Docket Items #6 & 7
BAR # 2018-00450 & 2018-00451

BAR Meeting
November 7, 2018

ISSUE: Partial Demolition/Capsulation, Alterations and a Waiver of Rooftop HVAC Screening Requirement

LOCATION: 102 Quay Street

EXISTING QUAY STREET FACADE SHOWING PROPOSED DEMOLITION

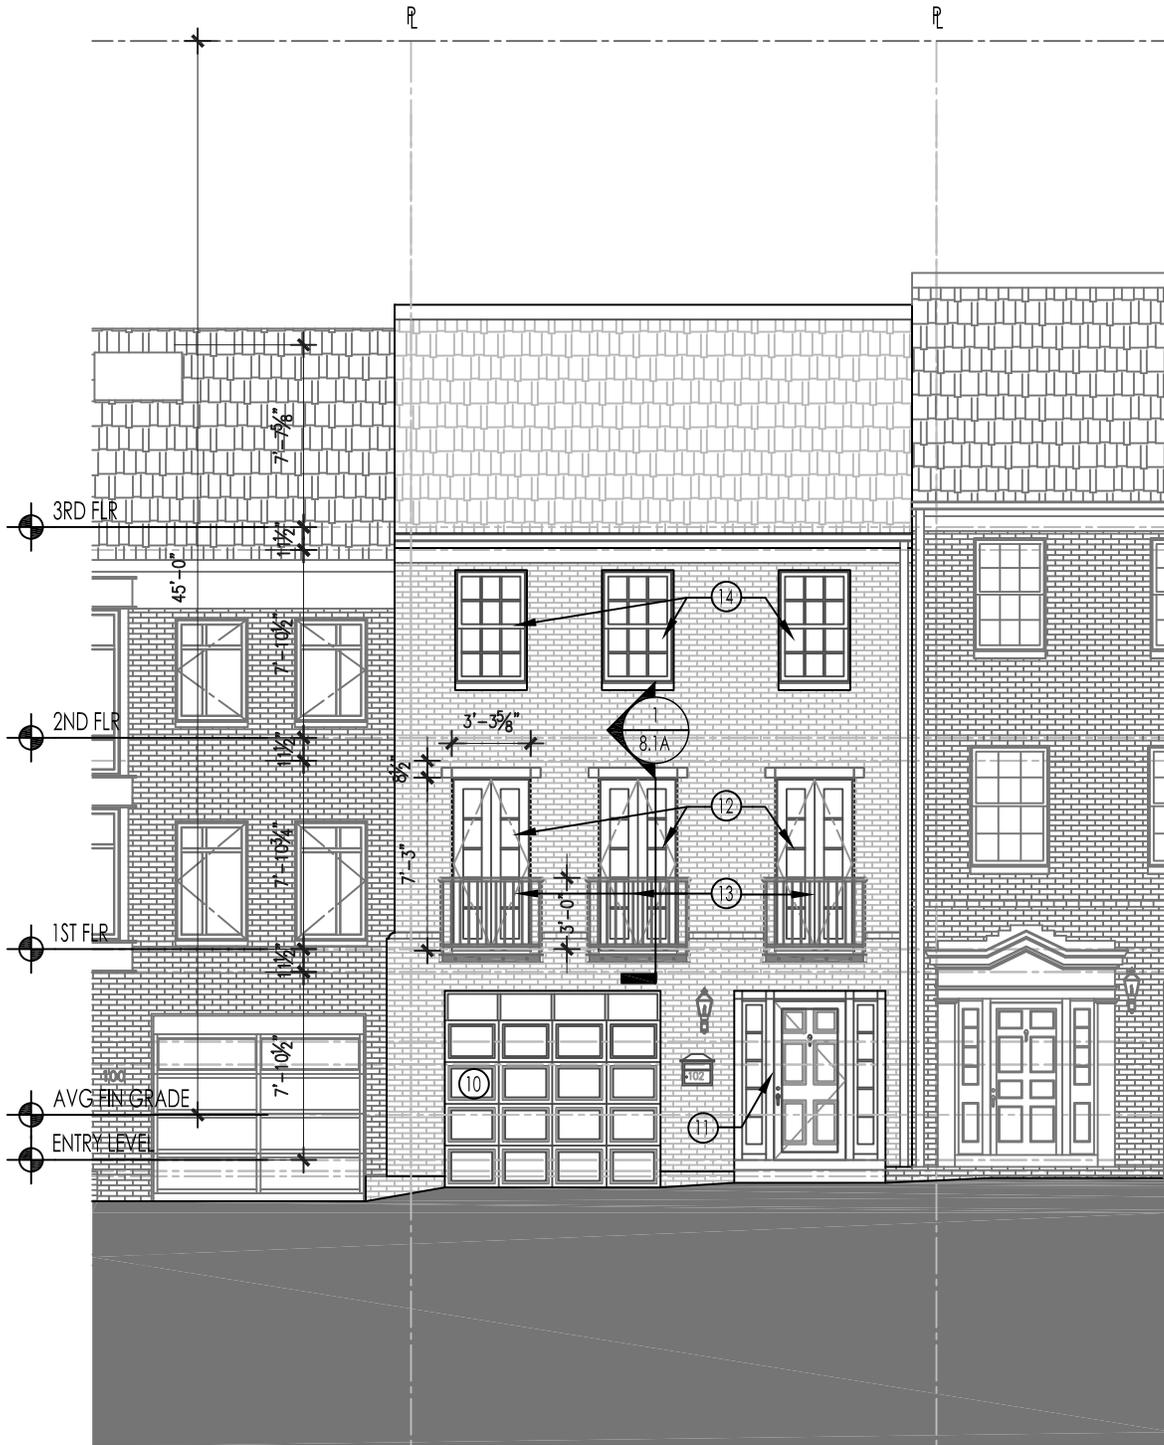
Demolition is limited to the area under the three double-hung windows on the front façade for the installation of three French doors.

Staff has no objection to the demolition of the limited portion of the front façade on this 1971 house finding that it meets none of the criteria listed above. The material proposed for demolition is not old or unusual or of uncommon design and could be easily reproduced today.

PROPOSED QUAY STREET ELEVATION

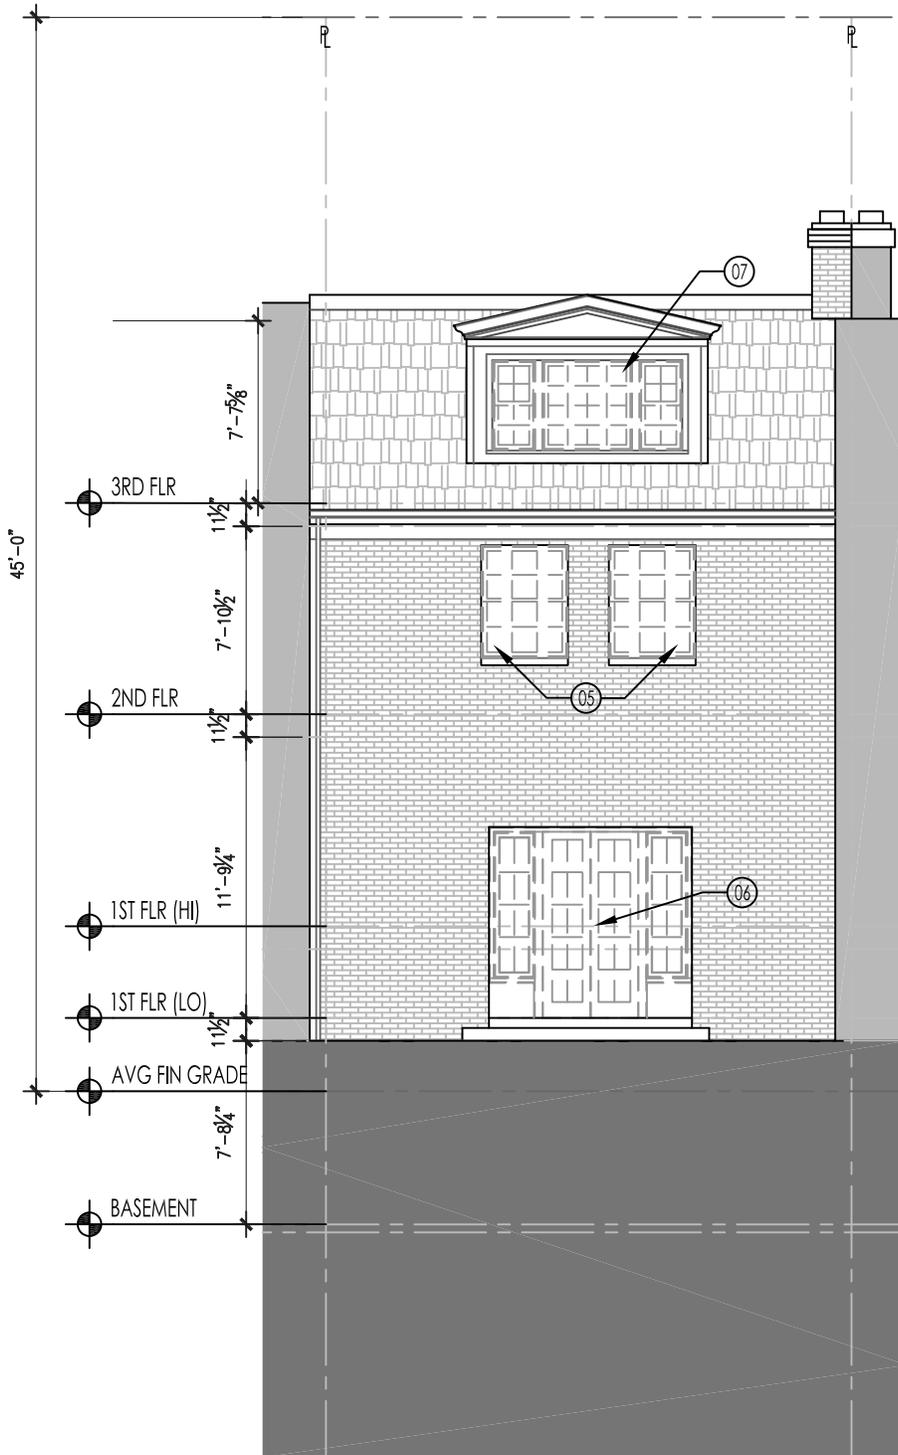
proposed are minor, using high-quality materials, and do not significantly change the overall design motif or the buildings composition. Staff only notes that the proposed aluminum-clad Jeld Wen window muntins have a beaded profile rather than the putty profile called for in the BAR's adopted window policy.

Staff recommends that the applications be approved, with the putty profile window muntin in lieu of the proposed beaded profile.
